From: Pallister, Donna [mailto:Donna.Pallister@arcadis-us.com]
Sent: Thursday, March 31, 2011 12:21 PM
To: Steve Fischbach
Cc: Reed, Ginny; Jeffrey Crawford; Tremblay, Stephen; Alan Sepe
Subject: RE: Location of new wells

SPRINGFIELD STREET SCHOOL COMPLEX SPRINGFIELD STREET PROVIDENCE, RHODE ISLAND	
SITE PLAN	
	FIGURE 2

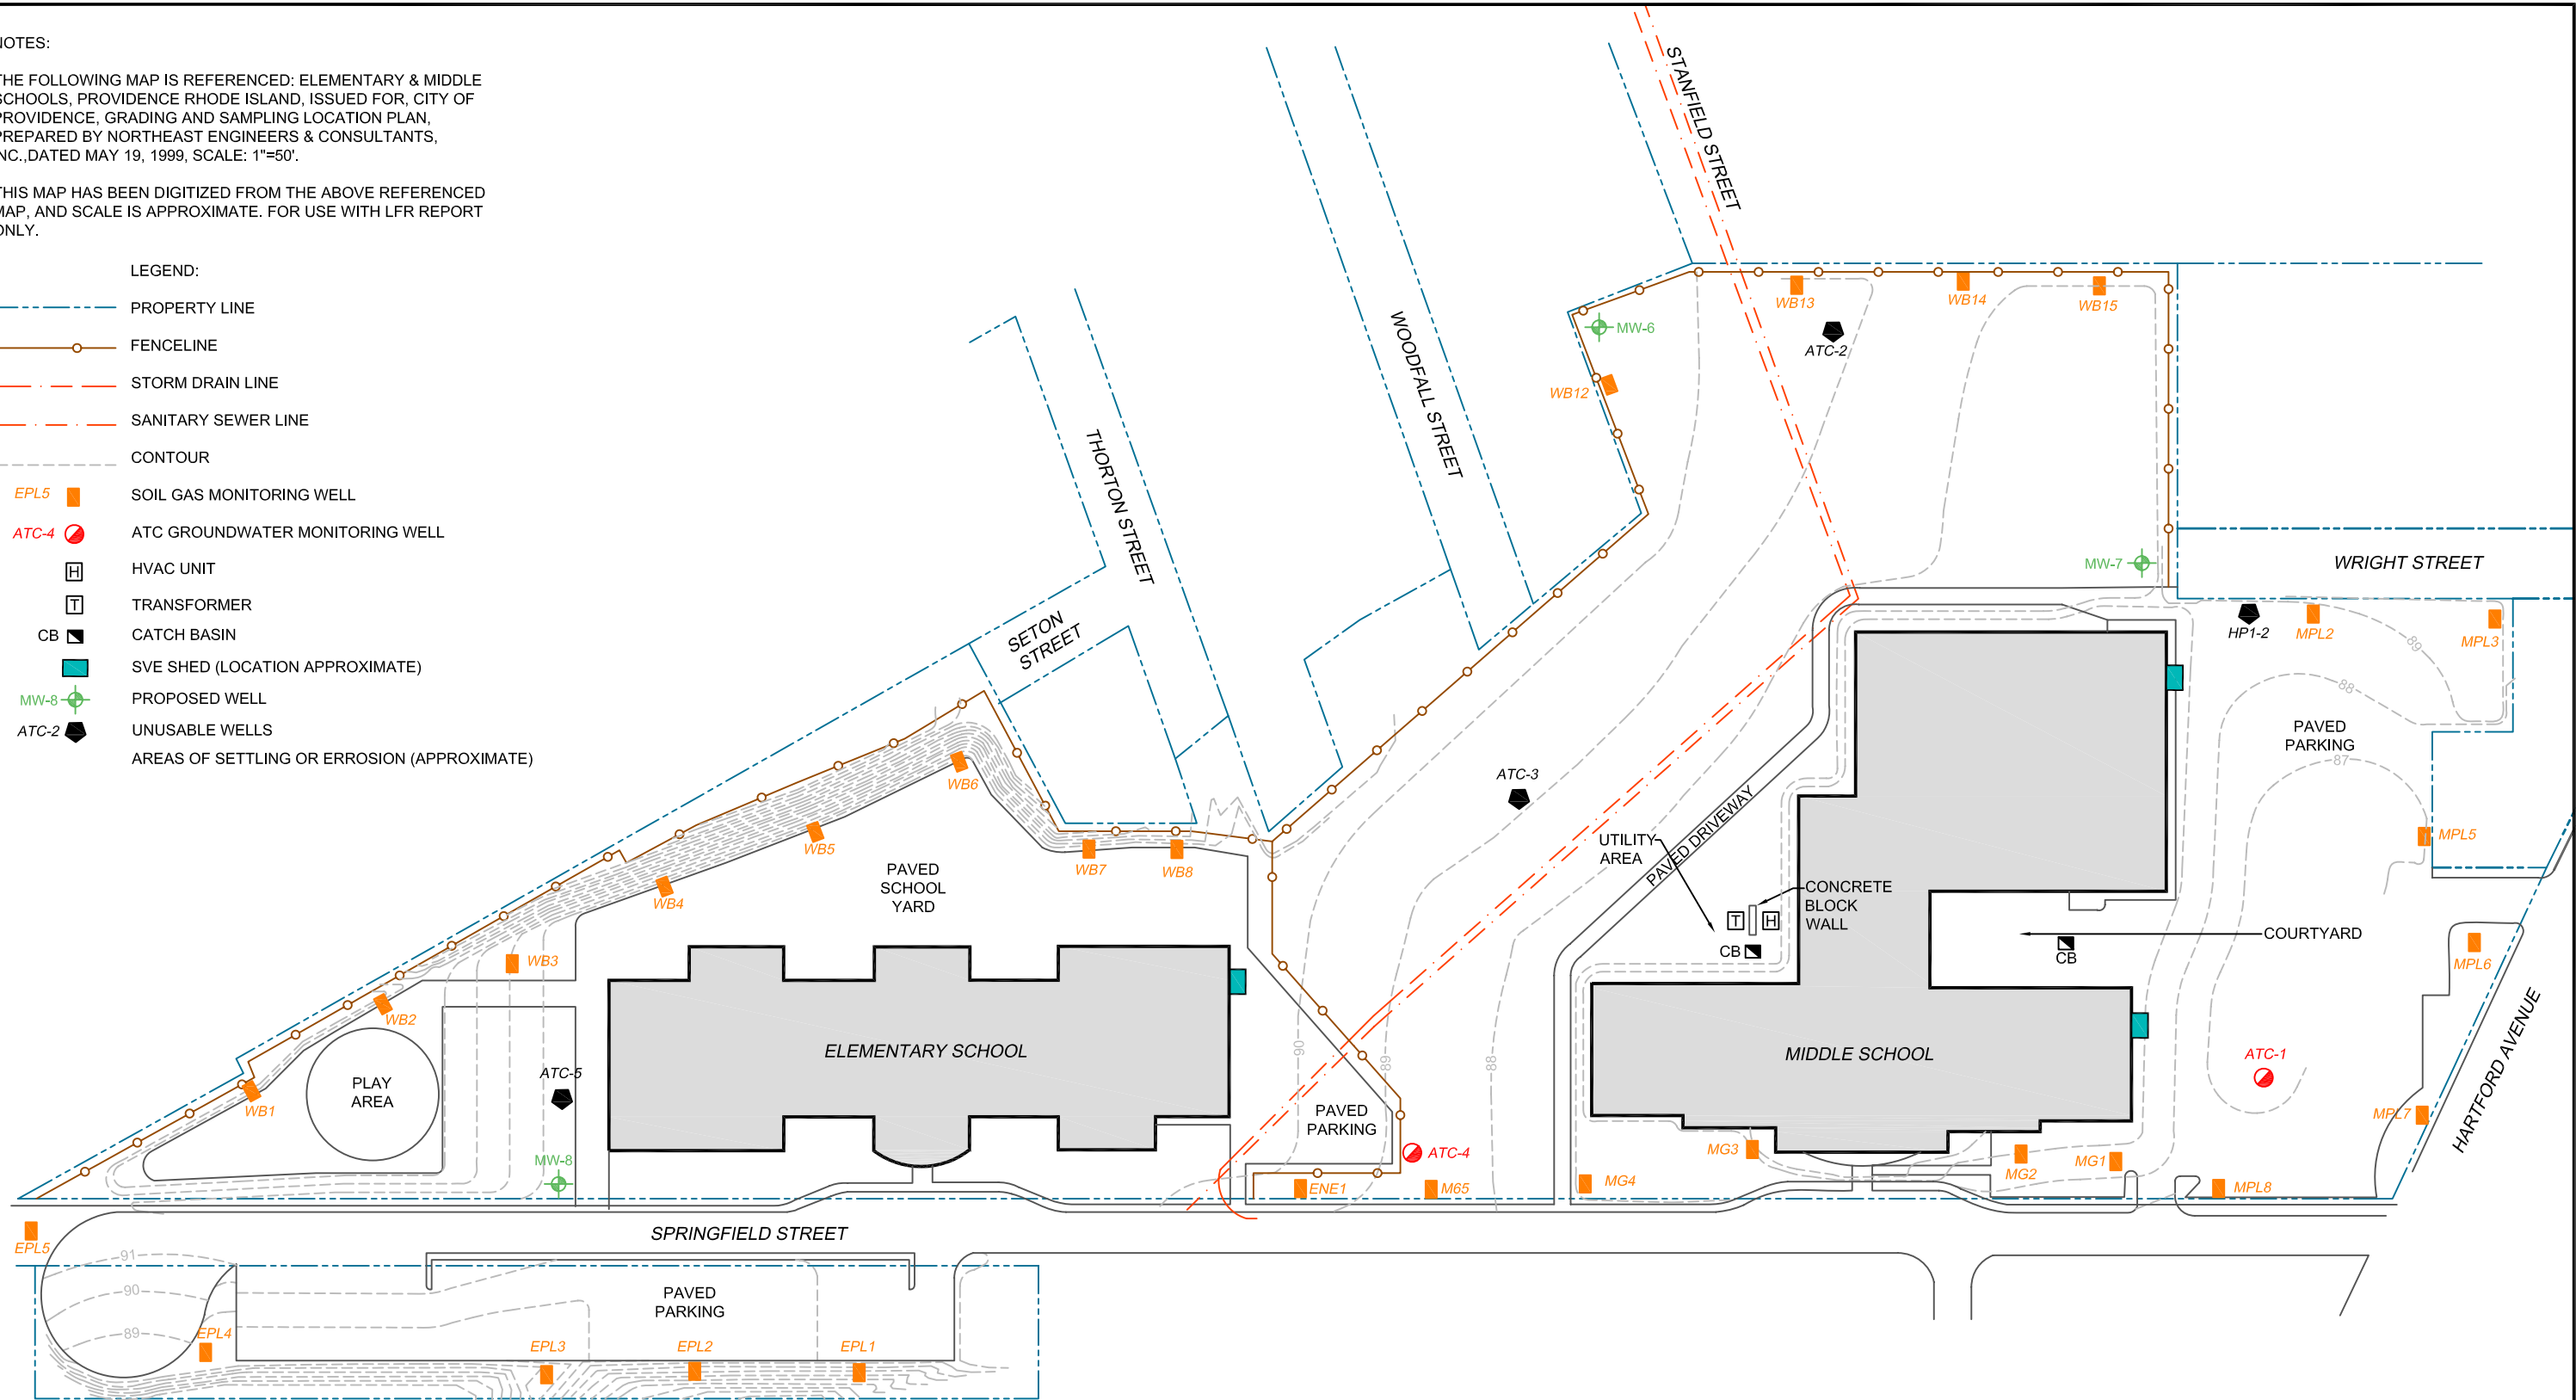
I sent the email below to Donna Pallister. I understand she is away until 4/1 and that you

Here's the figure. The proposed new wells are MW-5, MW-6 and MW-7, in green. These locations would be easier to maintain over the long term. No evidence of groundwater contamination has been detected since the first wells were installed during the SIR, so there is no evidence that a source exists that will impact groundwater in the future.
